Amendment to the Drawings:

Appl. No. 10/691,758
Response to 6/14/06 Office Action
Atty. Dkt. 12872-E (BA4-200)

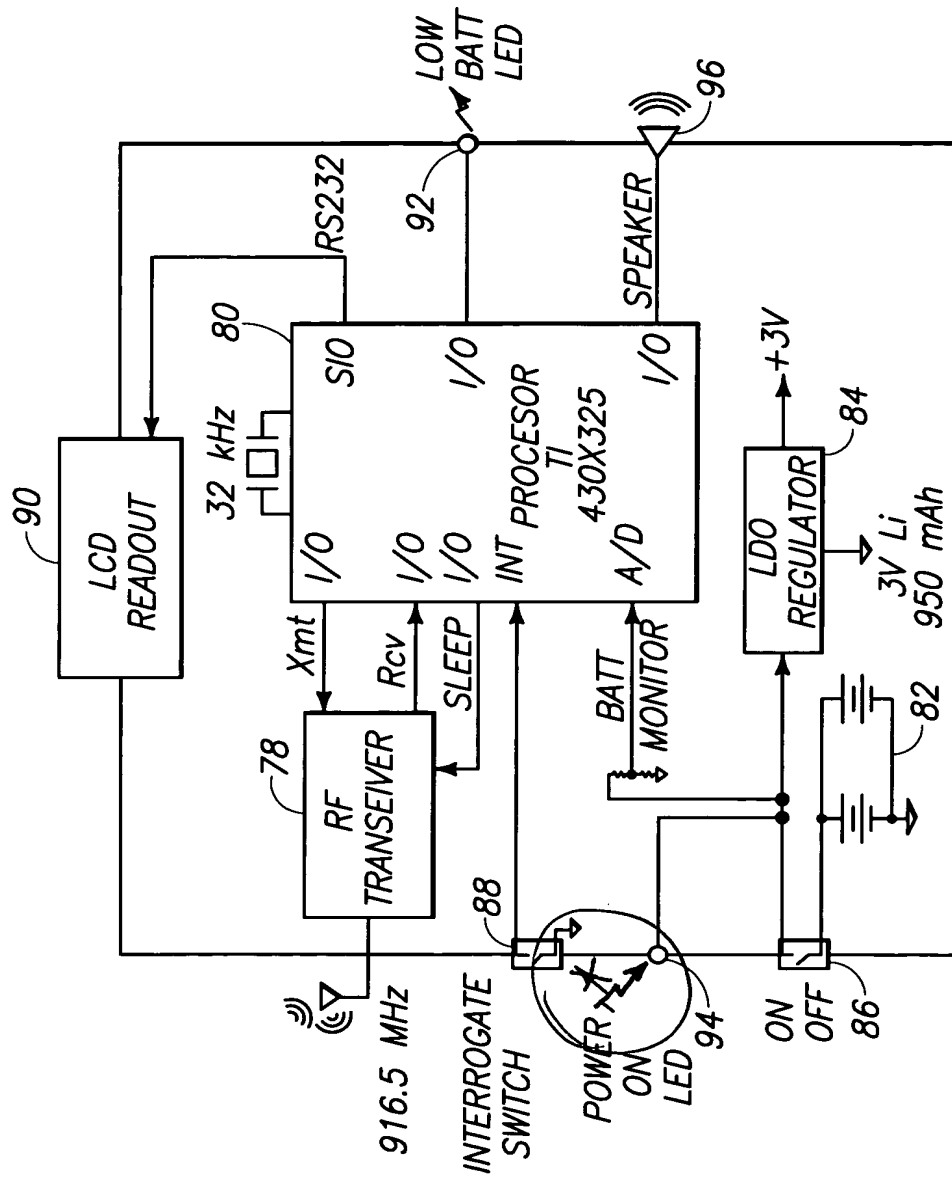
The attached sheets of drawings include changes to Figs. 2A and 2B.

In response to the drawings objections, Applicants hereby submit new formal Drawing Sheets 2 and 3, with the corrections made to Figs. 2A and 2B as required by the Examiner. Acceptance of these corrected drawings is respectfully requested.

New Sheet 2, which includes Fig. 2A, replaces the original sheet including Fig. 2A.

New Sheet 3, which includes Fig. 2B, replaces the original sheet including Fig. 2B.
